CITY OF ROCKWALL, TEXAS
 SQUABBLE CREEK FORCE MAIN

PLAN AND PROFILE
 STA. 90+00 TO STA. 95+00

BHC PROJECT NO. 2007-110	SHEET NO. 7
July, 2011

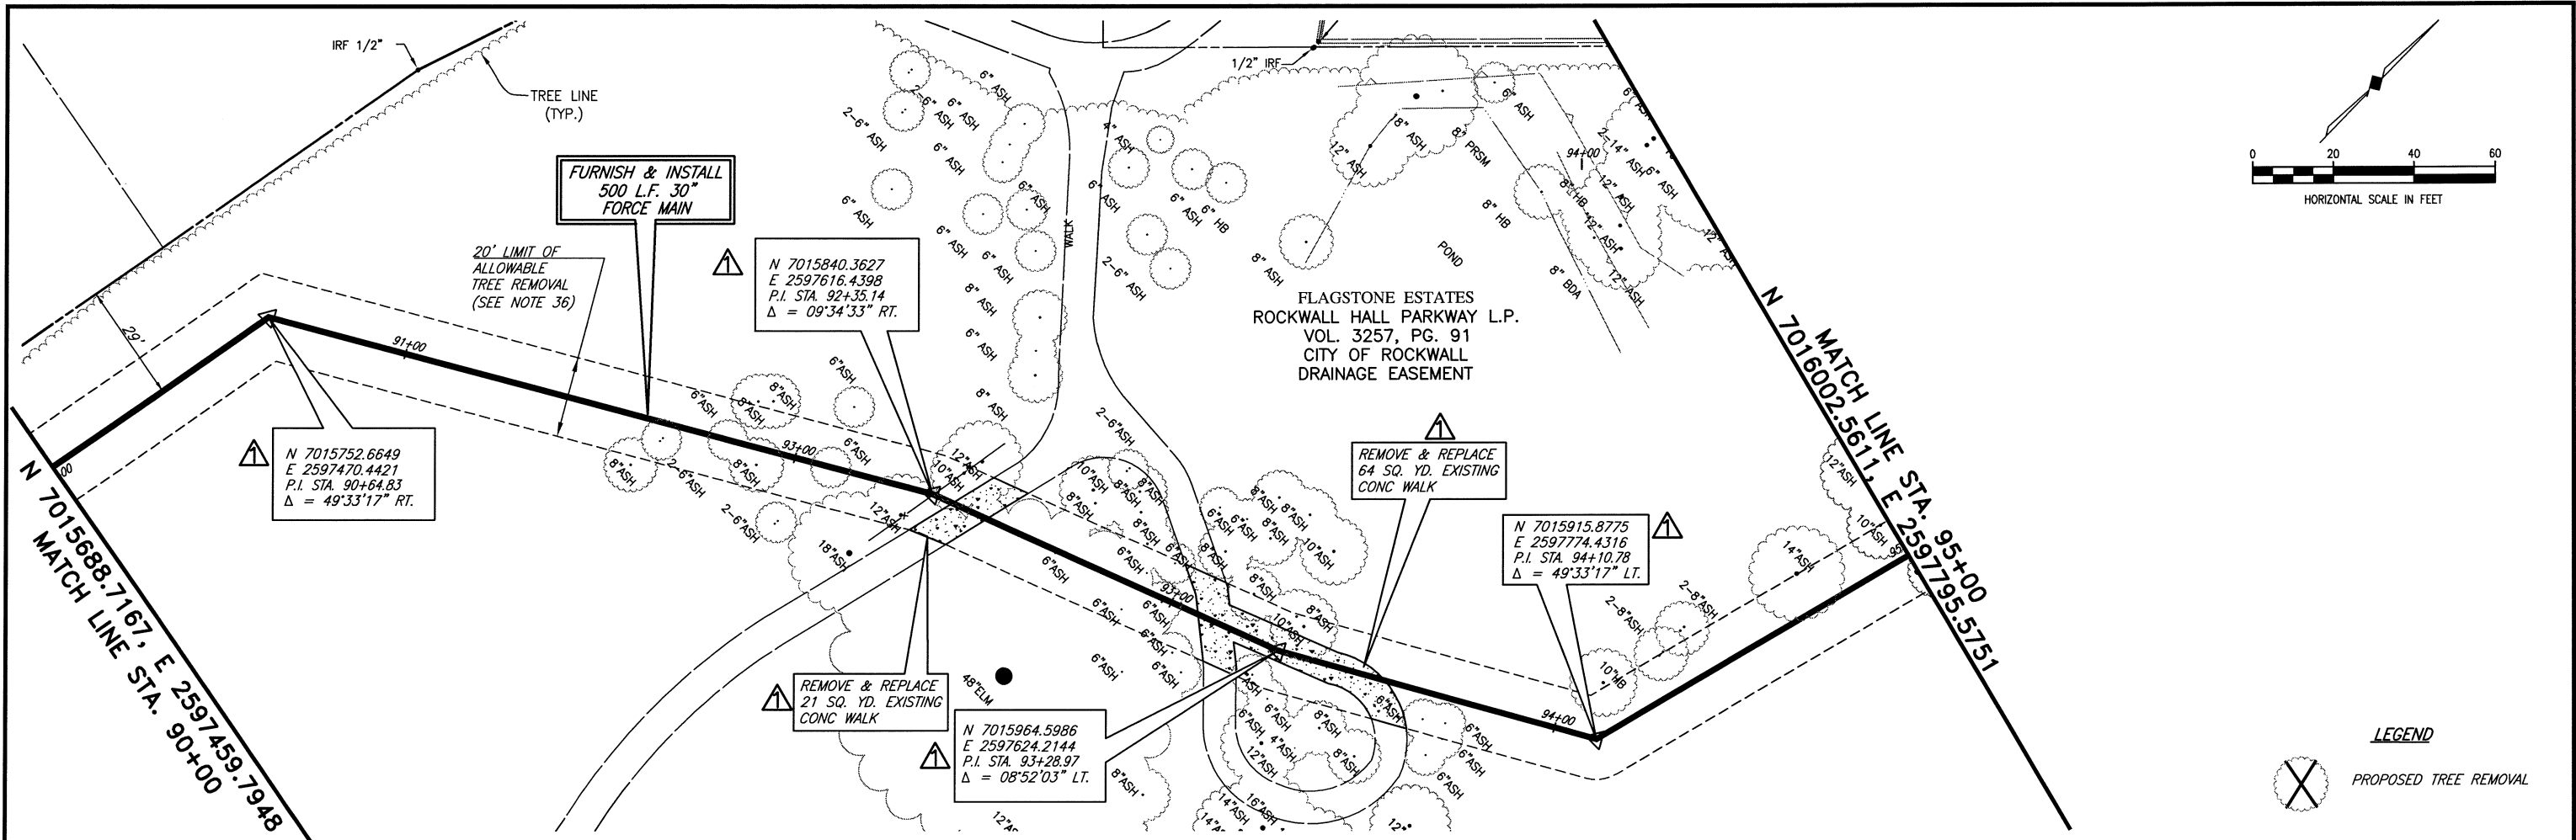
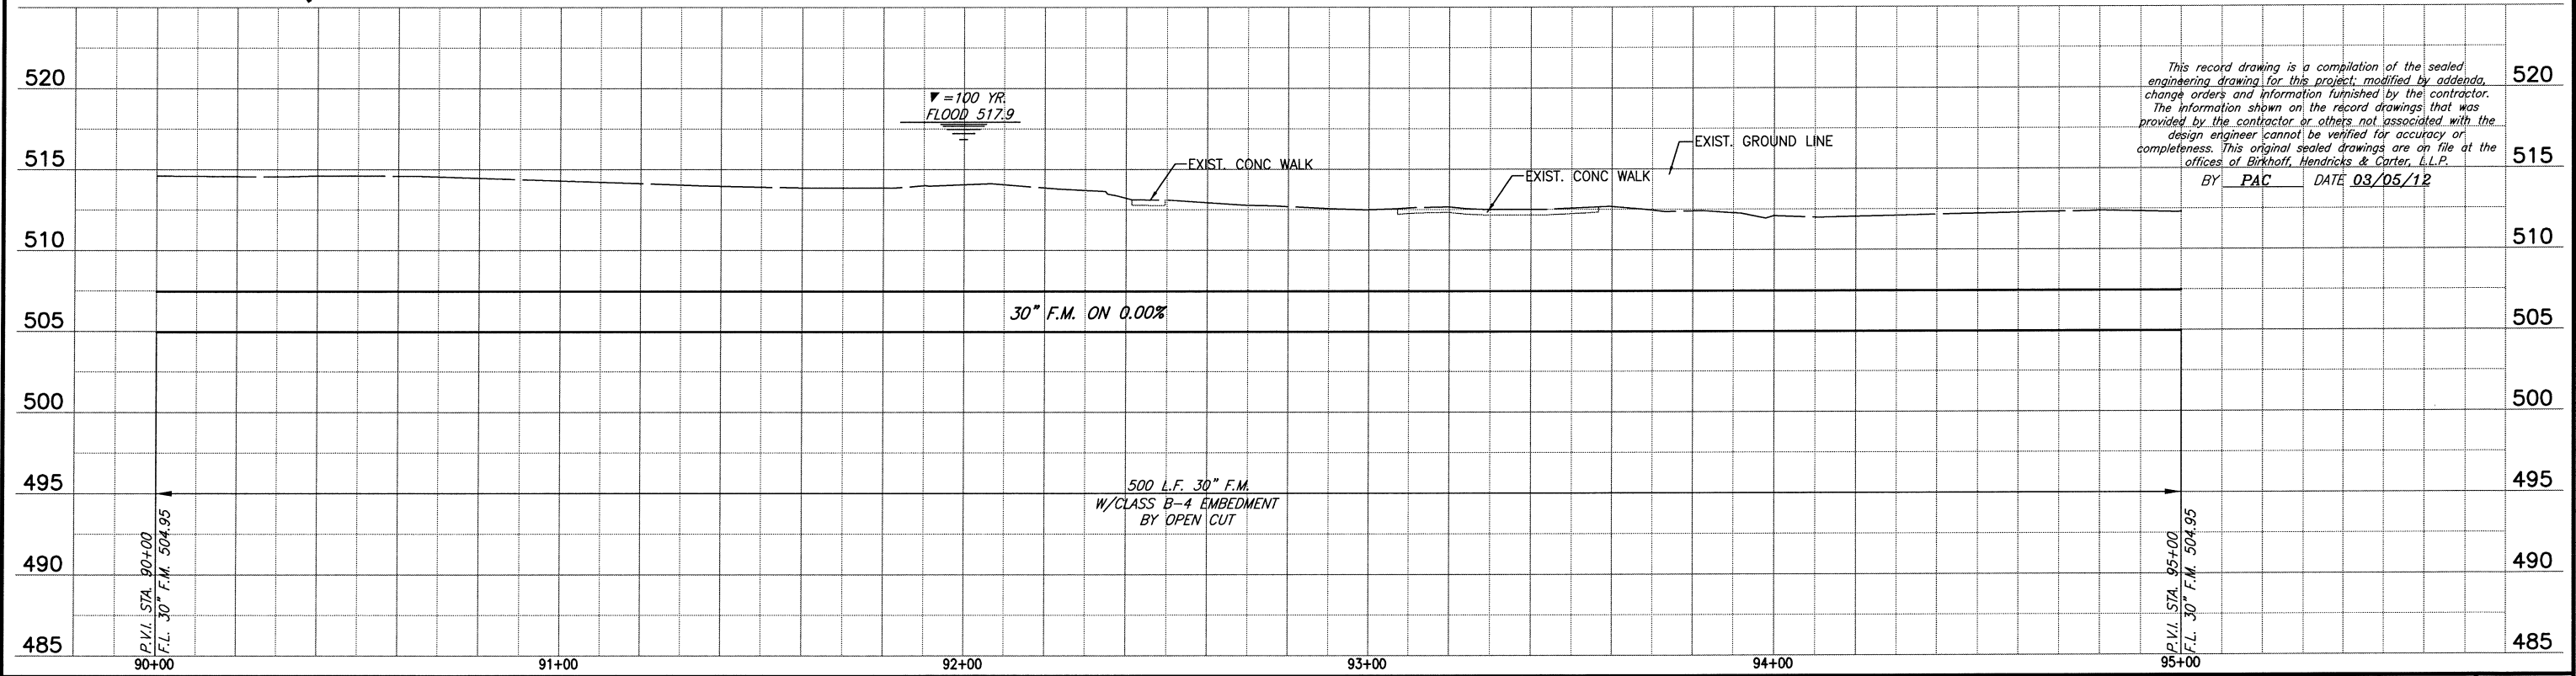
FIELD CHANGE NO. 1 - REVISED ALIGNMENT STA. 90+64.83 TO STA. 97+85.84 (STATION EQUATION!!)
